# UNITED STATES PATENT AND TRADEMARK OFFICE

APPLICATION NO.	FILING DATE	FIRST NAMED INVENTOR	ATTORNEY DOCKET NO.	CONFIRMATION NO.
10/714,232	11/14/2003	Arne W. Ballantine	PUG.0083CIUS (792c)	2447
21906	7590	06/15/2007		
TROP PRUNER & HU, PC 1616 S. VOSS ROAD, SUITE 750 HOUSTON, TX 77057-2631			EXAMINER ALEJANDRO, RAYMOND	
			ART UNIT 1745	PAPER NUMBER
			MAIL DATE 06/15/2007	DELIVERY MODE PAPER

<b>Office Action Summary</b>	<b>Application No.</b> 10/714,232	<b>Applicant(s)</b> BALLANTINE ET AL.	
	<b>Examiner</b> Raymond Alejandro	<b>Art Unit</b> 1745

## **DETAILED ACTION**

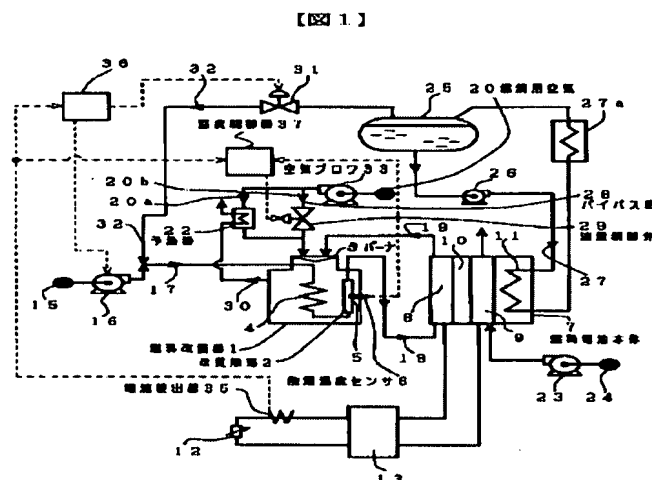
Figure 1 of the JP'365 illustrates a fuel cell power generating device (TITLE/ FIGURE 1) including a fuel cell 7 respective oxidant supply 24 and fuel supply 18 (FIGURE 1) which are provided for power generation; and a controller 36 for controlling fuel cell operating parameters (FIGURE 1). Particularly, controller 36 controls flow rate control valve 29 in response to conditions sensed by both temperature sensor 6 (heat sensor) and a current detector 35 (power

demand sensor), and which is further adjusted according to a load current value of the fuel cell main body 7 (Abstract/Constitution).

Particularly, the JP'365 discloses that controller 36 controls flow rate control valve 29 in response to conditions sensed by both temperature sensor 6 (heat sensor) and a current detector 35 (power demand sensor), and which is further adjusted according to a load current value of the fuel cell main body 7 (Abstract/Constitution). *Thus, control of at least fuel flow is based on the sensed temperature and the measured current and the load current value of the fuel cell. In this case, it is noted that the controller of the JP'365 is capable of performing the claimed function based on the particular sensed conditions. Thus, the controller of the JP'365 inherently controls the fuel cell system as instantly claimed in claims 52-55 and 57-58. In other words, the examiner is asserting inherency based on the structural and functional similarities between the disclosed controller and applicant's controller. In re Schreiber, 128 F.3d 1473, 44 USPQ2d 1429 (Fed. Cir. 1997).*
